Job name: Land West of Arundel Road, Angmering

Note No: C86473-JNP-66-XX-RP-T-1002

Subject: Section 73 Application – Supporting Technical Note

Title:
**Commercial Access - General Arrangement
1no Footway, North Side**

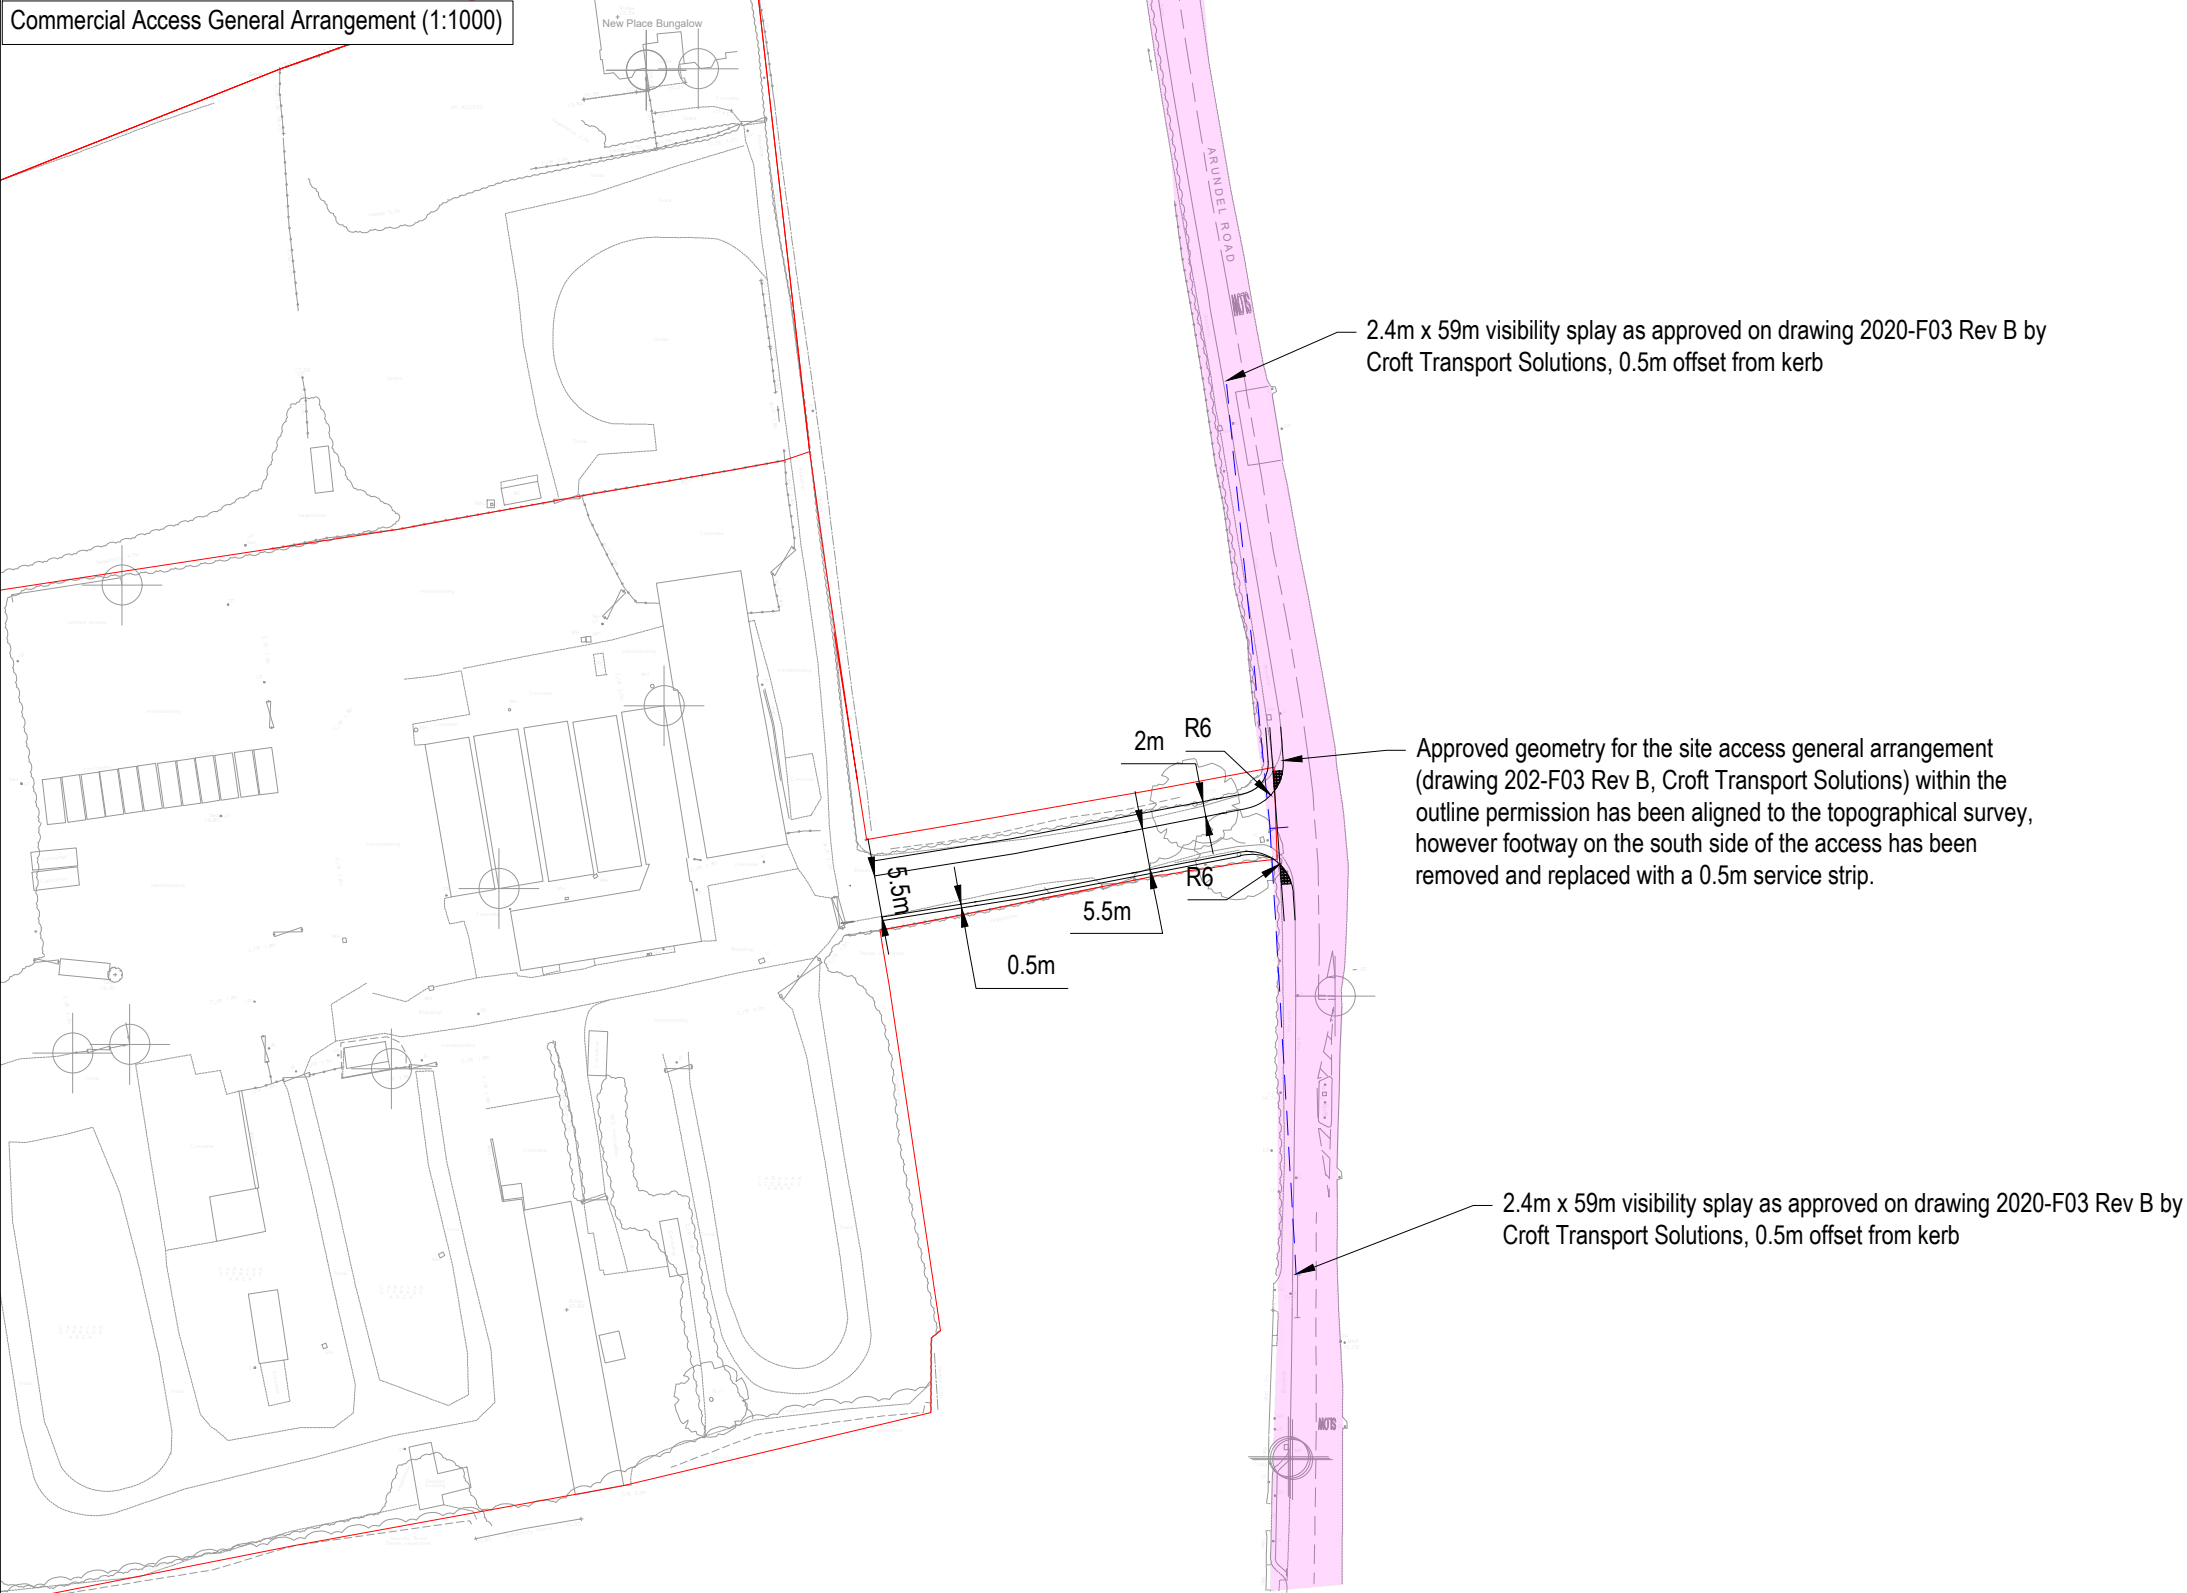
- 3.5 Upon updating the drawings to the topographical mapping as a base, rather than OS, it was identified that the general arrangement of the commercial access as approved is not viable or deliverable

within the constraints of the land ownership. This was not accurately reflected on the OS mapping, which shows a more generous geometry between the land ownership extents than what exists in reality.

- 3.6 On this basis, it is necessary to revise the commercial access general arrangement to provide a deliverable solution.
- 3.7 A revised access design has been prepared and is provided at the rear of this Technical Note as drawing **C86473-JNP-66-XX-SK-T-7007-P01**. It is proposed that the access is amended to provide the following:

- Dropped kerbs and tactile paving at the bellmouth, forming an uncontrolled crossing.
- 3.8 The primary changes is the omission of the footway on the south side of the road. It is also proposed that tactile paving is provided at the bellmouth, which was not provided in the previously approved general arrangement. There are no changes to the achievable visibility splays from the junction, which remain as approved (2.4m x 59m).

- 3.9 The removal of the southern footway is necessary in order to accommodate the bellmouth of the junction within the land ownership. The provision of two footways means that the kerb radii of one footway falls outside of the site's red line boundary.

- 5.5m carriageway;
 - 6m kerb radii;
 - 1no footway on the north side of the carriageway, 2m wide;
 - 0.5m wide service strip on the south side of the carriageway;

- 3.10 The provision of one footway along the commercial access is not expected to have a detrimental impact on highway safety or discourage pedestrian trips. Pedestrians who are entering the site from the south will be able to cross the bellmouth at the proposed uncontrolled crossing and continue into the site using the footway on the north side. The arrangements can be completed in reverse for those egressing the site and travelling south.
